RFQ NUMBER
DEP13016

Subject: Addendum to DEP 13016 Belle Contracting Pre-bid Conference Corrections, Questions & Answers

LINE	QUANTITY	UOP	CAT. NO.	ITEM NUMBER	UNIT PRICE	AMOUNT
***** ADDENDUM NO. 2 *****						
ADDENDUM ISSUED FOR THE BELL CONTRACTING PROJECT TO DISTIRBUTE THE CHANGES IN SCOPE OF WORK AND THE TYPICAL DRAWING AS DESCRIBED IN THE ATTACHED MEMO FROM THE AGENCY.						
BID DATE & OPENING TIME ARE THEREFORE EXTENDED FROM 01/21/2009 TO 01/29/2009 AT 1:30 PM.						
***** NO OTHER CHANGES *****						
0001	1	JB		962-73		
RECLAMATION: RESTORATION OF LAND						
***** THIS IS THE END OF RFQ DEP13016 ***** TOTAL:						439,002.00

LINE	QUANTITY	UOP	CAT. NO.	ITEM NUMBER	UNIT PRICE	AMOUNT
***** ADDENDUM NO. 3 ***** ADDENDUM ISSUED TO CLARIFY THE BID OPENING DATE FROM THE TYPO IN ADDENDUM NO. 2 ISSUED ON 01/20/09. THE BID OPENING DATE IS 01/29/2009 AT 1:30 PM, AS REFLECTED CORRECTLY IN THE BID OPENING DATE SECTION OF THIS FORM ABOVE. PLEASE NOTE THE INCLUDED DRUG FREE WORKPLACE CONFORMANCE AFFIDAVIT IS NOW MANDATORY WITH SUBMISSION OF THE BID. ***** NO OTHER CHANGES *****						
0001	1	JB		962-73	\$	439,002.00
				RECLAMATION: RESTORATION OF LAND

OFFICE OF SPECIAL RECLAMATION	
BELLE CONTRACTING BRIDGE REPAIR	
SCALE: NOT TO SCALE	DRAWN BY:
DATE:	PROJECT NO:

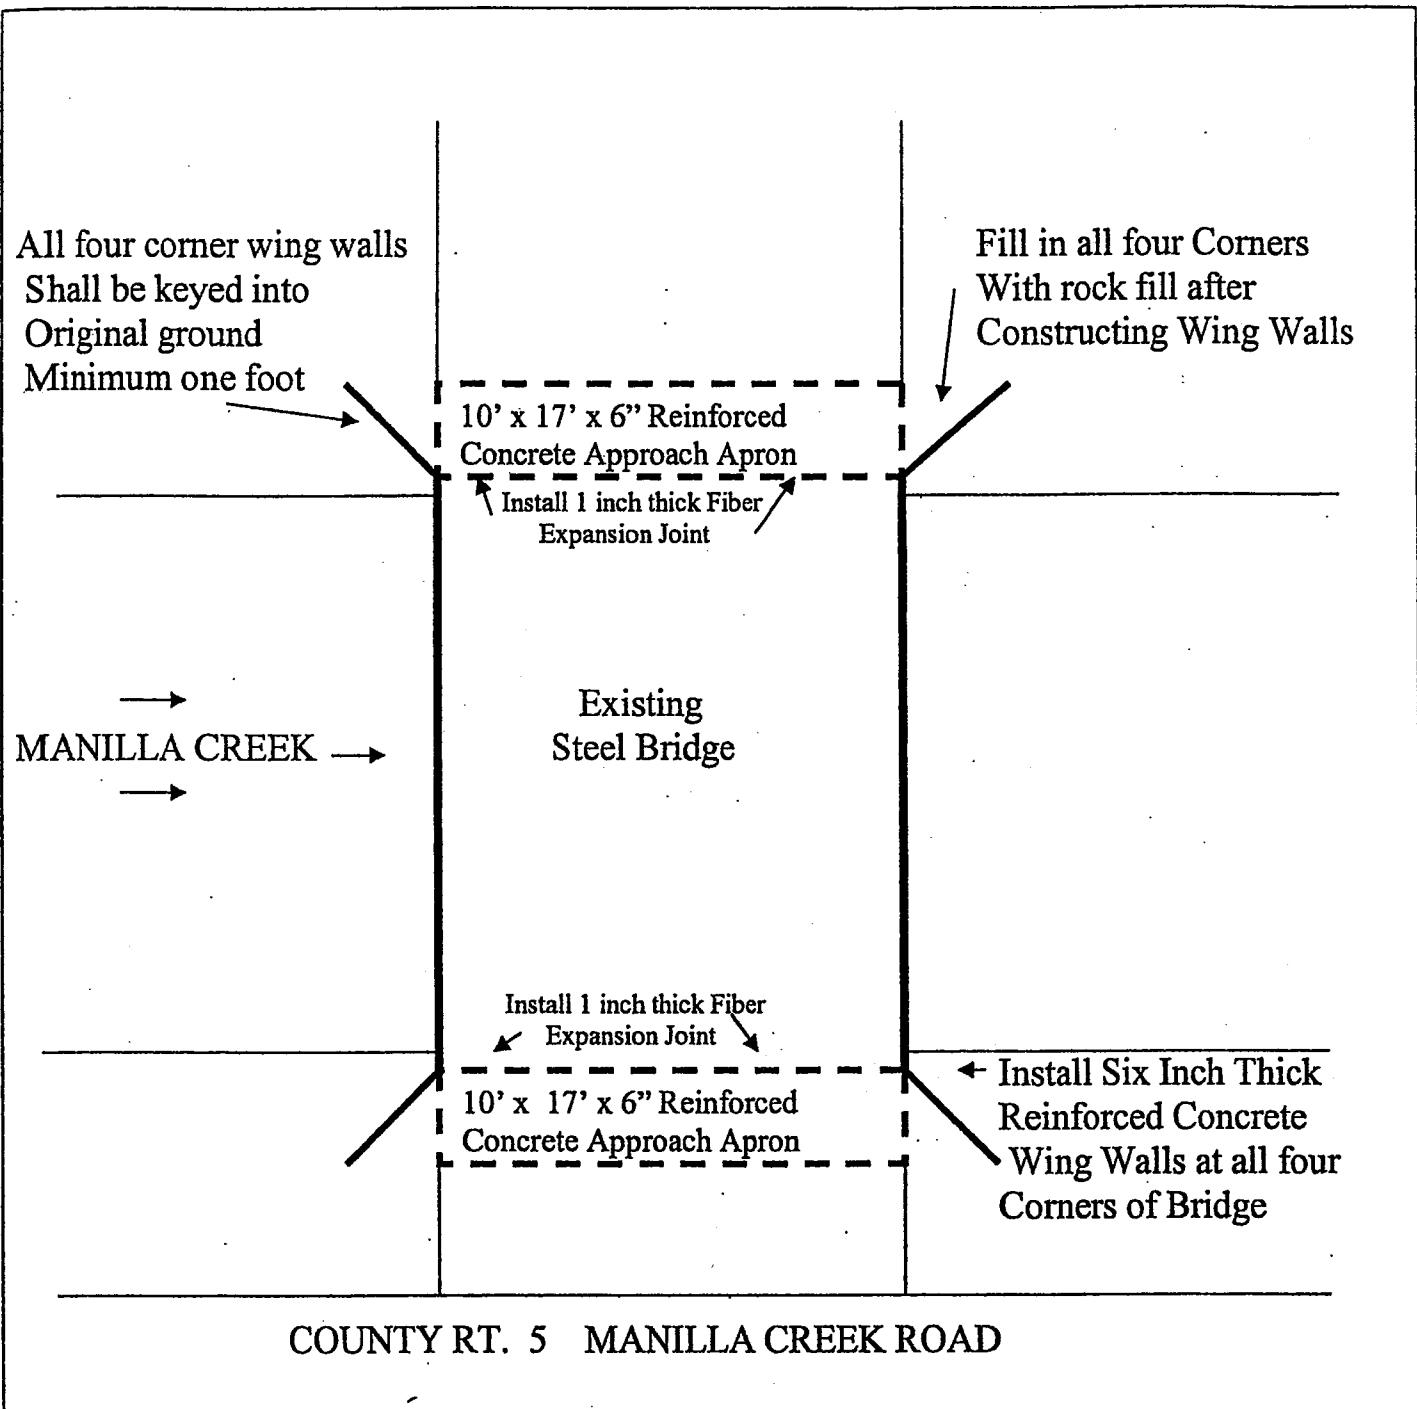
4. The note at the bottom of drawing "Belle Contracting bridge repair", page 45, now reads:

GROUTED RIP-RAP HEADWALL AT 60 inch CULVERT

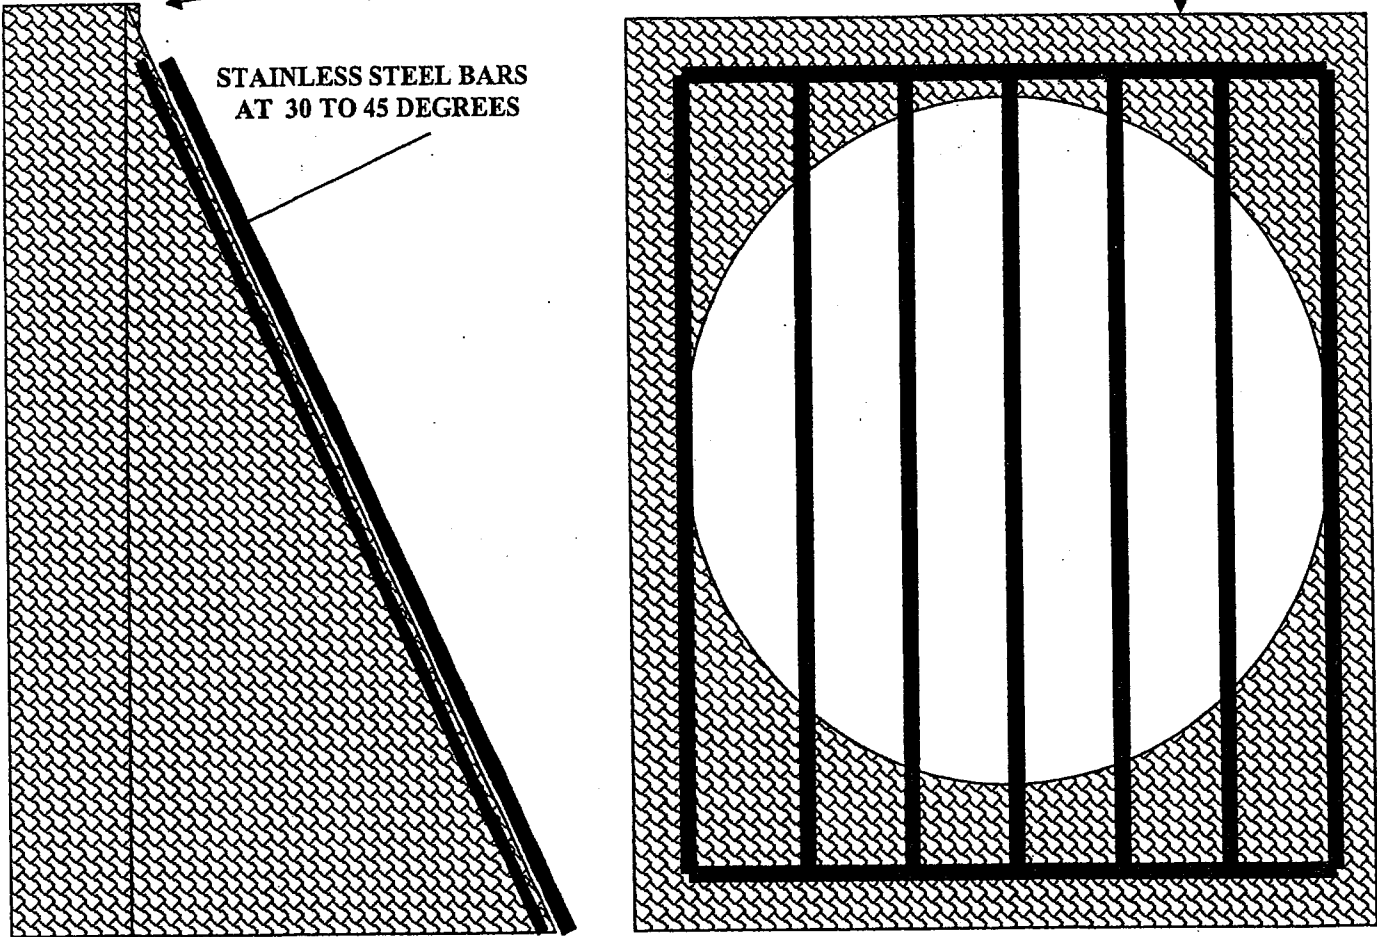
5. The drawing "Stainless steel trash rack typical attachment" on page 48 needs to have all references to stainless removed. A carbon steel trash rack will be acceptable.
6. The note on page 61, Sludge pump line attachment Ponds 1 & 2, now reads"

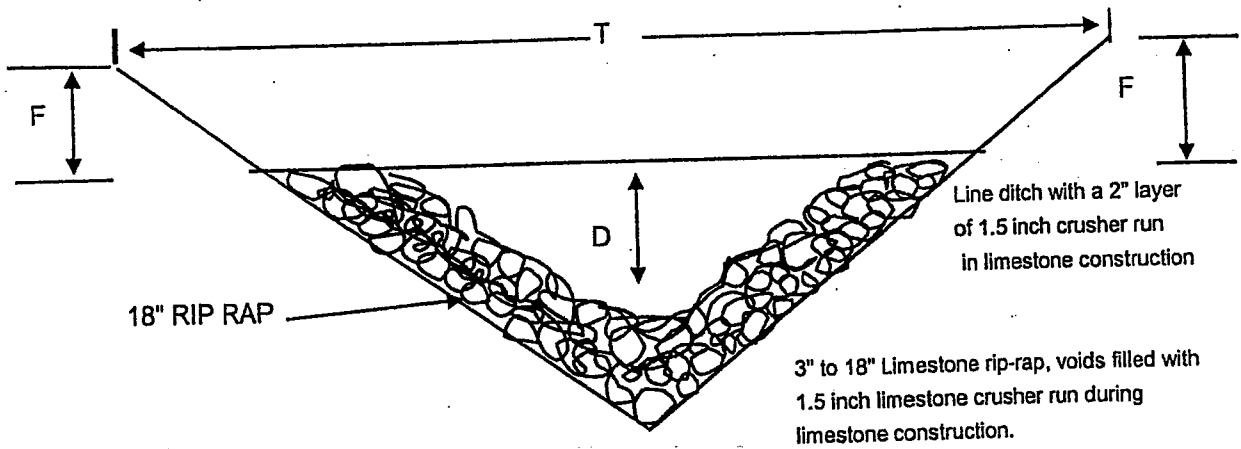
2. The note under the Typical "V-ditch" drawing (page 64) now reads:
